WALSIN TECHNOLOGY CORPORATION

Change Notification

CN No.: CN-R190105	<input checked="" type="checkbox"/> Material <input type="checkbox"/> Specification	<input type="checkbox"/> Process <input type="checkbox"/> Others	
Subject : Unify the top side termination shape for 0402/0603/0805/1206 thin film products.			
Reasons : Unify the top side termination shape for 0402/0603/0805/1206 thin film products.			
Contents(Before/After):

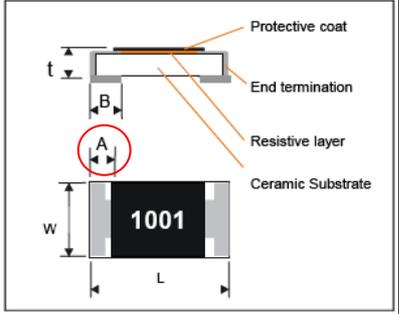
2. All Products P/N remains no change. 3. Electrical property remains no change. 4. Products visual appearance is changed, but "A" specification remains no change.			
Top side terminal All thin film products for 0402/0603/0805/1206 size	Current Top side terminal is window shape. 	After Top side terminal is Bar shape. 	Top side terminal length (A) specification A specification remains no change
